West Street, Andover

26-081-RPT-001 Rev -

Highways Technical Review

Figure 1.1: Extract of Proposed Scheme

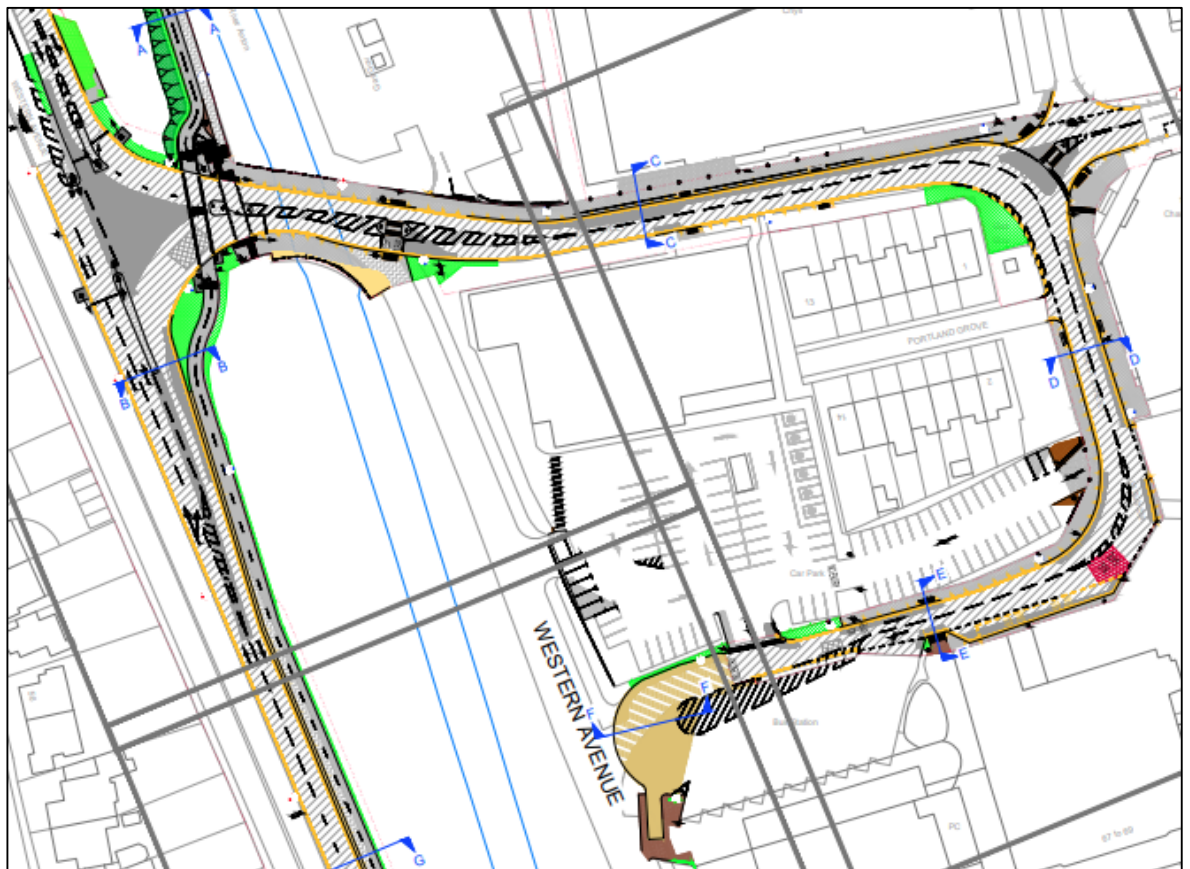
- 1.1.5 The scheme within West Street involves the general widening of the carriageway to facilitate two-way traffic movements, reconfiguration of the northern junction with Western Avenue, reconfiguration of the bus station layout and alterations to the access arrangements for the Lidl supermarket.
- 1.1.6 The proposals are supported by numerous technical drawings, including vehicle swept path analysis, geometry and visibility measurements. In addition, the scheme has been subject to a Stage 1 Road Safety Audit, undertaken by HCC. This supporting material has been technically reviewed, and any arising issues / concerns are set out in the following report.

Figure 2.1: Amenities Surrounding West Street

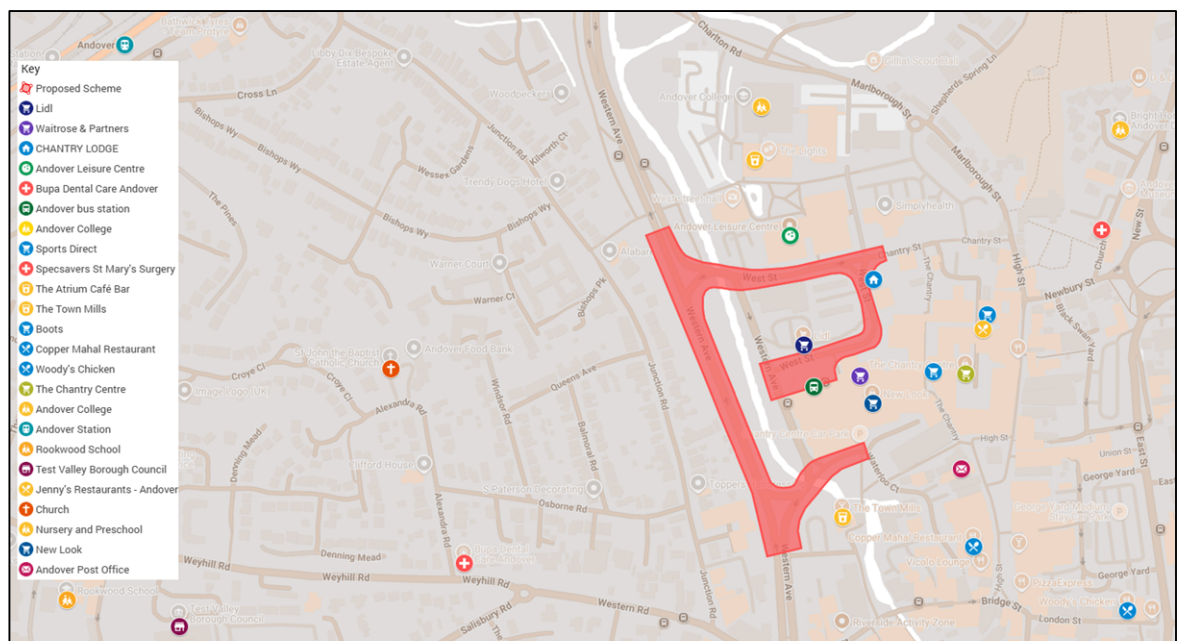
2.1.2 It is important to consider the context of the site and surrounding facilities in terms of the likely 'desire lines or routes' for active travel users. As indicated in the **Figure 2.1** below, there are a number of amenities in close proximity to the proposed scheme that would generate pedestrian and/or cyclist trips, such as Andover College and the Leisure Centre to the north, the Chantry Lodge retirement flats and the Lidl and Waitrose supermarkets on West Street itself; and the High Street area to the south.

2.1.3 Given the concentration of educational, retail, leisure and residential uses in the vicinity, the importance of maintaining direct, convenient and attractive active travel routes is clear.

Figure 2.2: Footway Reduction on West St (South of Leisure Centre)

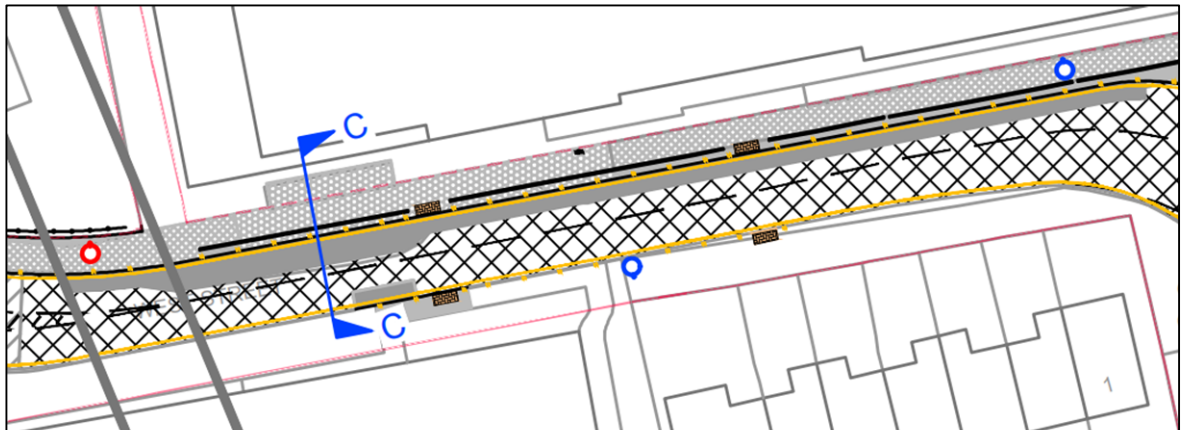
- 2.1.4 Furthermore, it is apparent that the most direct route between these complementary land uses would be via West Street. As such, any highway improvement scheme in this area should suitably cater for, and indeed incentivise, travel by active travel modes.
- 2.1.5 Contrary to this, the proposed scheme significantly reduces the existing footway provision at several locations on West Street and is lacking in terms of suitable crossing facilities. The reductions in footway are highlighted by the dark grey areas in the scheme extracts shown in the figures below.

Figure 2.4: Footway Reduction on West St (North of Waitrose & Bus Station)

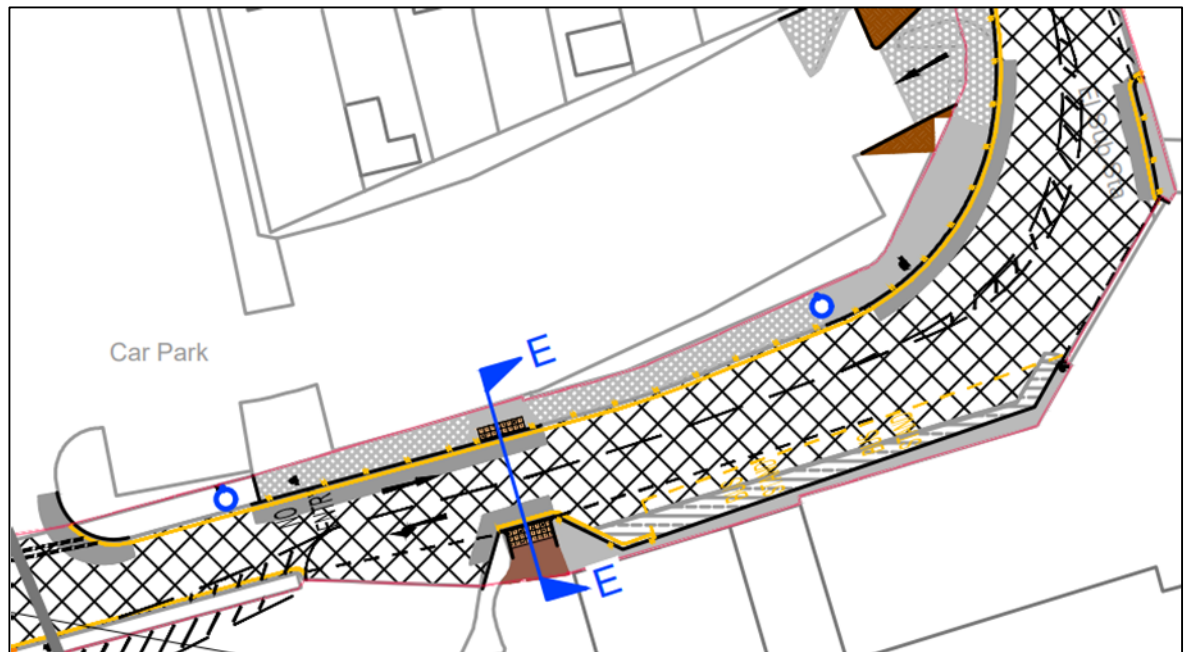
- 2.1.6 In addition to the reduction in footway provision, the proposed scheme lacks legible routing for pedestrians along West Street. The proposed scheme requires pedestrians to cross the road on several occasions to move through West Street, for example, pedestrians moving between Andover College and the High Street would need to cross the road a minimum of three times to navigate their route. Furthermore, there would likely be vulnerable users of the scheme in the context of the surrounding land uses, such as children from the college and leisure centre and elderly users from Chantry Lodge.
